SERVICE BULLETIN

DATE: APRIL 22, 2002
RIDE: SILVER STREAK/ FAMILY HIMALAYA
SUBJECT: SWEEP INSPECTION (16 SWEEPS)
COMPLIANCE: MANDATORY
COMPLETION DATE: IMMEDIATELY

SWEEP INSPECTION

4H 105

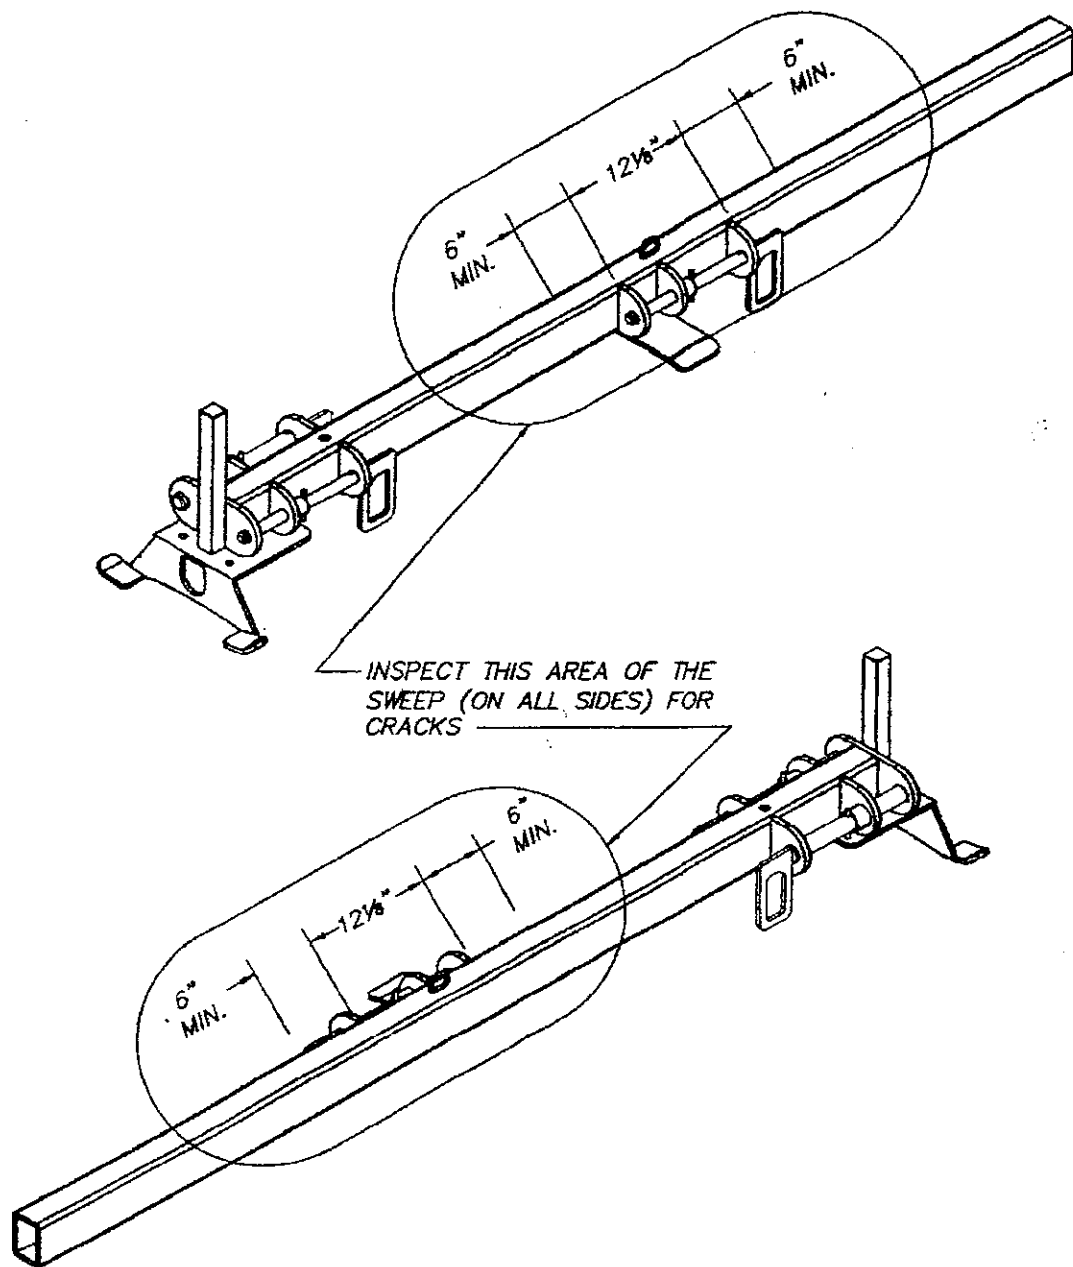
One Family Himalaya has experienced cracking on one sweep where the inside seat attachment is welded. Review the drawing on the reverse side and inspect for cracking around the sweep. If cracks are indicated contact Wisdom Industries at 800-634-6907 for repair or replacement of the sweep before continuing operation.

1. Clean area on each sweep where the inside seat attachment is welded.
All 4 sides of sweep. (See Drawing)
2. Visually inspect 6" each side of the attachment for cracks on all 4 sides of the tubes.
3. Follow the visual inspection with magnaflex or dye penetrant.
4. If cracks are found contact Wisdom Industries before operating the ride.
5. Repeat for the other 15 sweeps.
6. Repeat inspection on a semi annual basis

INSPECT THIS AREA OF THE
SWEEP (ON ALL SIDES) FOR
CRACKS
